**Interim  
Work Authorization**

IWA No. 15

Project Name: GST Airport Apron, Runway, and Taxiway Pavement Rehab

This IWA authorizes payment to modify finished grade, place and compact CABC, and extend the paving limits at the south end of the General Aviation Apron in accordance with revised sheets F8 and F10.

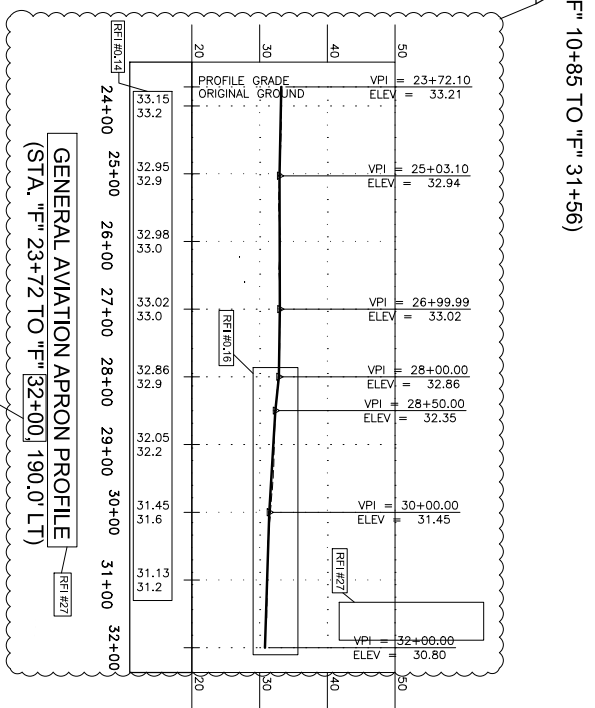
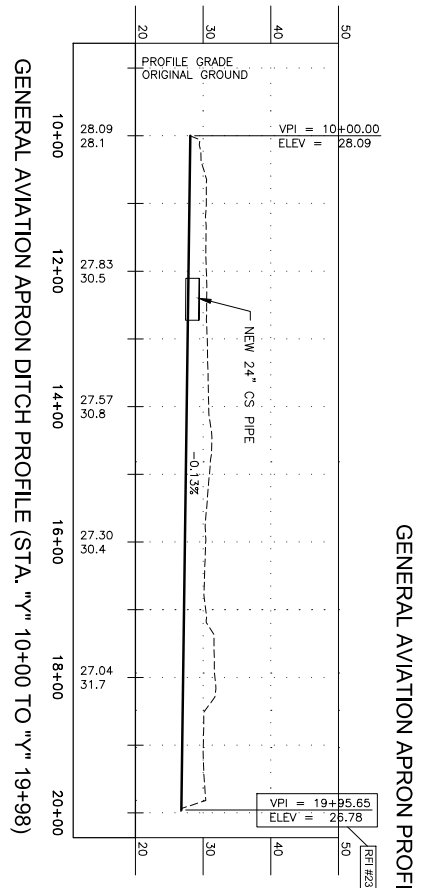
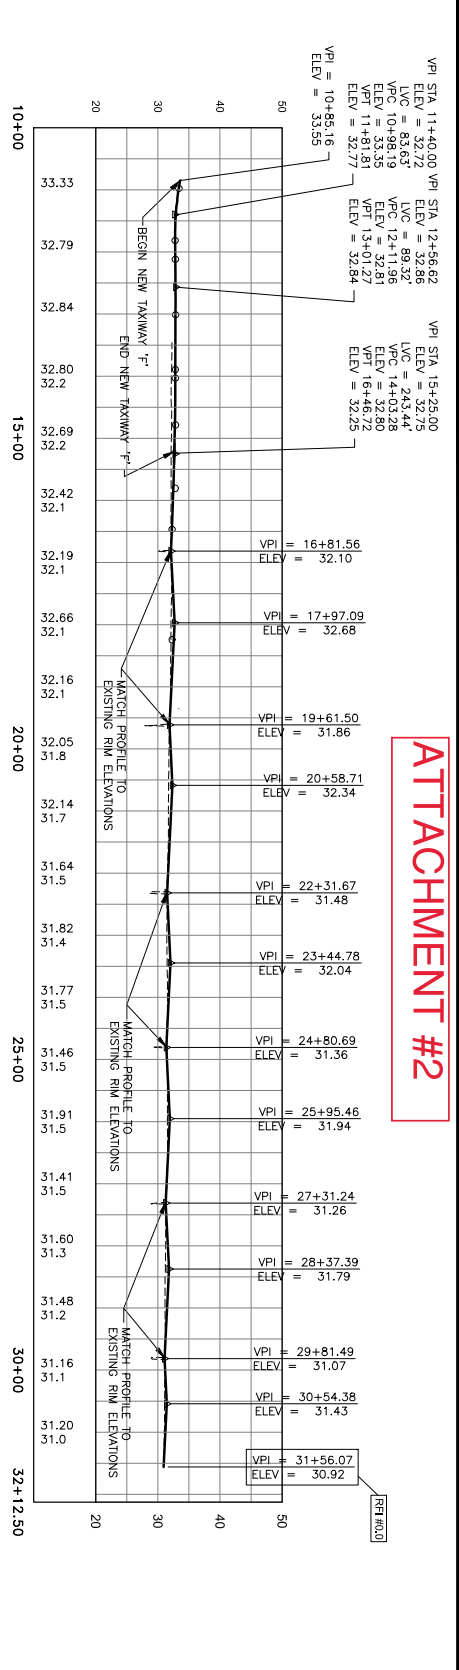
**SHEET F10:** Replace with new plan sheet identified as "Attachment 2."
